ADDENDUM NO. 02

PROJECT: Pleasantville Union Free School District
PMS HVAC Replacement

CPL PROJECT NO. 15131.07

DATE: November 10, 2022

**AD-2
SK-1**

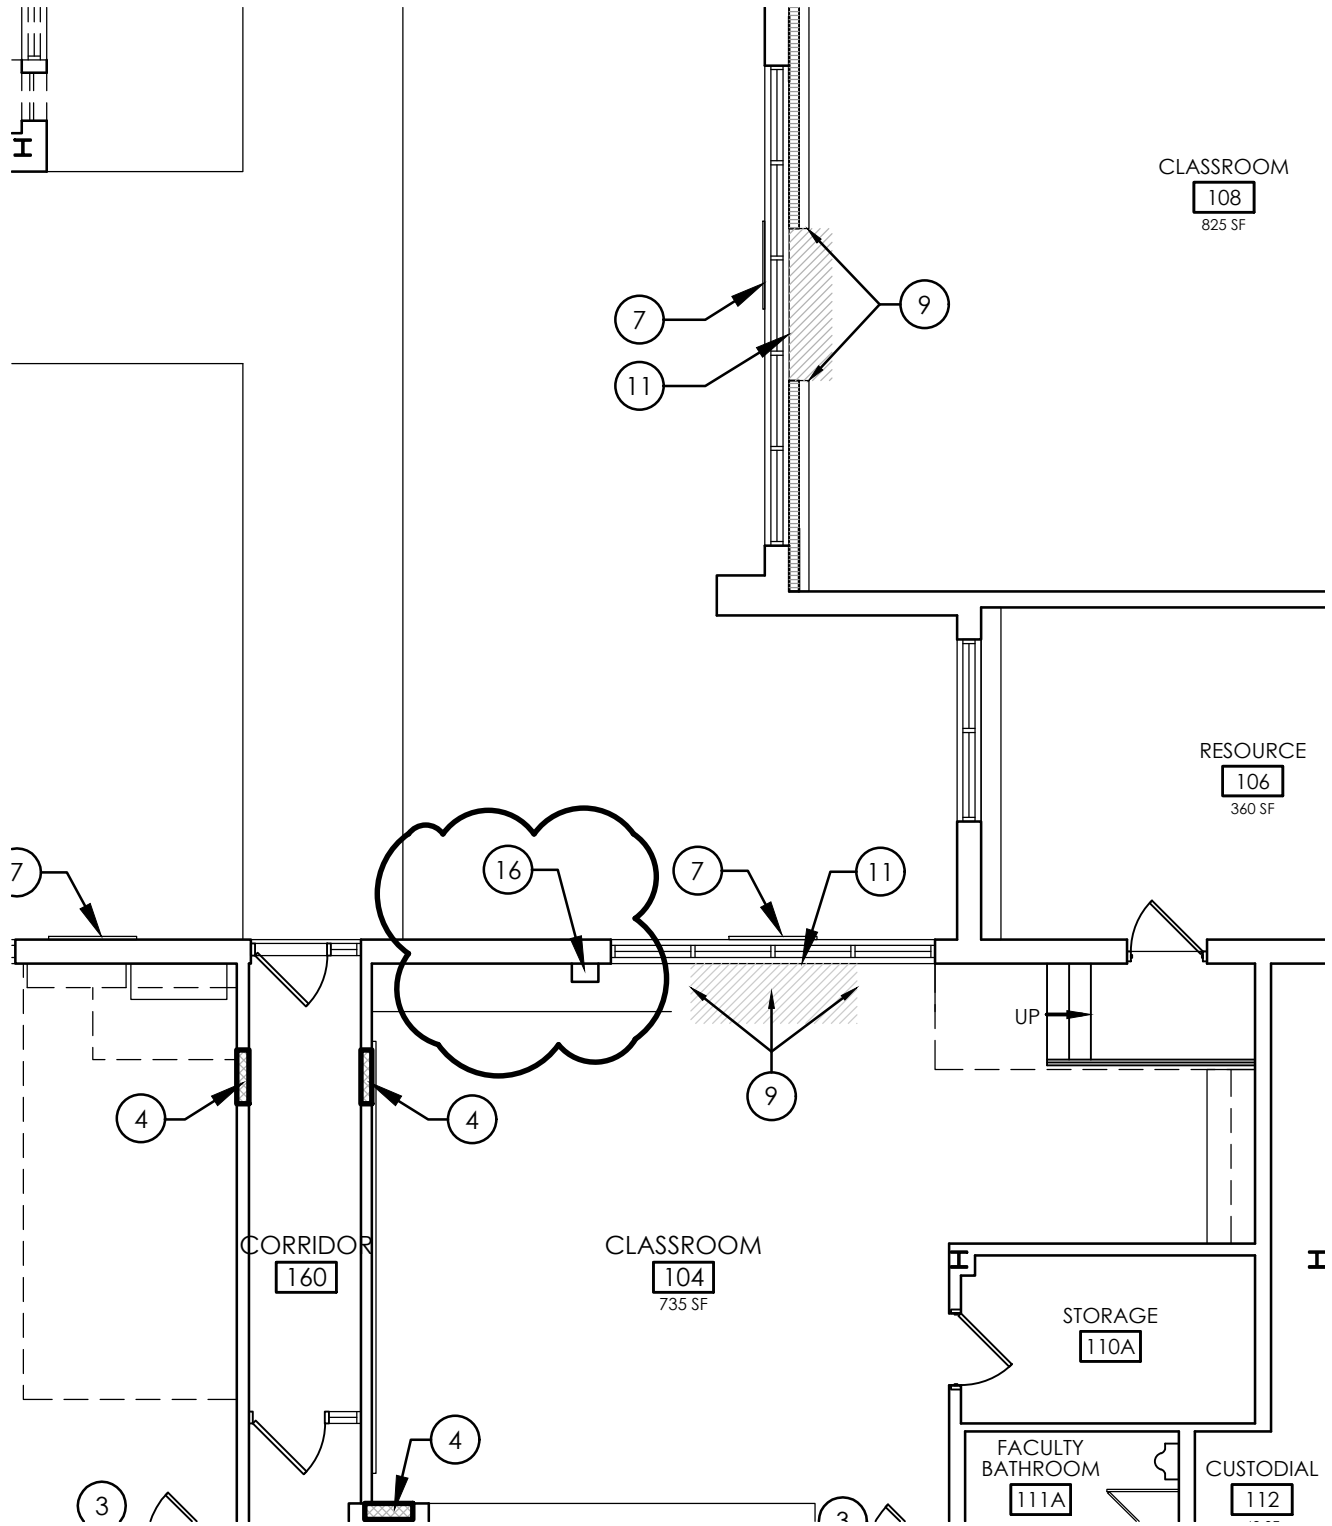
- 3.1 Drawing A200B: **Revise** sheet with attached sketch AD-2 SK-1.
- 3.2 Drawing A201C: **Revise** sheet with attached sketch AD-2 SK-3 and AD-2 SK-4.

**AD-2
SK-2**

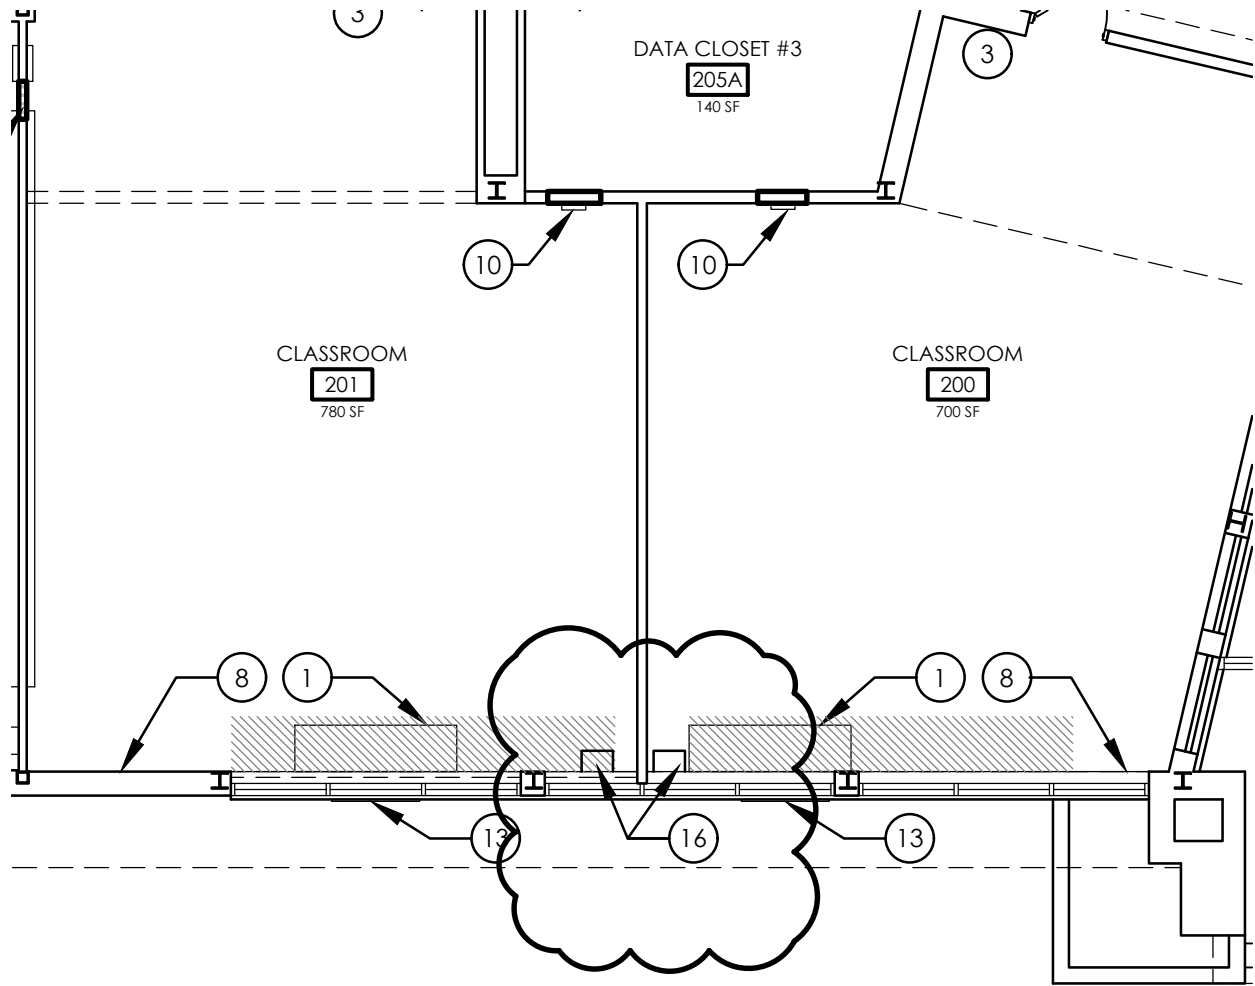
- 3.3 Drawing A200A through A201C: **Revise** sheet with attached sketch AD-2 SK-2. Note Reconstruction Keynotes have been revised for all Reconstruction sheets.
- 3.4 Drawing H300B: **Replace** sheet with attached sheet H300B
- 3.5 Drawing H301C: **Replace** sheet with attached sheet H301C
- 3.6 Add drawing H805 to drawing set.

- ① NEW UV TO BE INSTALLED BY MC.
- ② PREP, PRIME AND PAINT WALL AT LOCATION OF SPLIT SYSTEM REMOVAL.
- ③ PREP, PRIME AND PAINT WALL AT LOCATION OF TEMPERATURE CONTROL REMOVAL.

- ④ INFILL WALL PENETRATION WITH 1-HOUR RATED WALL CONSTRUCTION.
- ⑤ EXTERIOR WALL PENETRATION TO BE INFILLED MASONRY CONSTRUCTION.
- ⑥ INFILL WALL PENETRATION.

- ⑦ INFILL WALL OPENING PER DETAIL 6/A700 AT UV GRILLE
- ⑧ RECOVER EXPOSED WALL WITH 3/8" LAMINATING GYPSUM BOARD.
- ⑨ REFINISH EXPOSED ENDS OF EXISTING CASEWORK, INCLUDING NEW BASE.

- ⑩ PAINT AND RE-INSTALL EXISTING VENT COVER.
- ⑪ PATCH WALL WITH GYPSUM BOARD AND PAINT TO MATCH EXISTING.
- ⑫ ENCLOSE FRONT OF GAP AT END OF CASEWORK WITH MATCHING PANEL. PROVIDE FINISHED EDGE WHERE SOLID COUNTER WAS CUT; EASE COUNTER AGAINST NEW WALL.

- ⑬ INFILL WALL OPENING PER DETAIL 3/A700 AT UV GRILLE
- ⑭ PAINT NEW WALL TO MATCH EXISTING ADJACENT. PROVIDE NEW WALL BASE TO MATCH EXISTING ADJACENT.

⑮ PROVIDE 2'x2' WALL MOUNTED ACCESS DOOR. BASIS-OF-DESIGN: ASUDOR 10-2002.

⑯ PROVIDE METAL SHROUD OVER NEW CONDENSATE LINES. SHROUD TO BE PAINTED TO MATCH EXISTING WALL AND FOLLOW CONDENSATE LINES FROM THE CEILING TO THE NEW UNIT VENTILATOR.
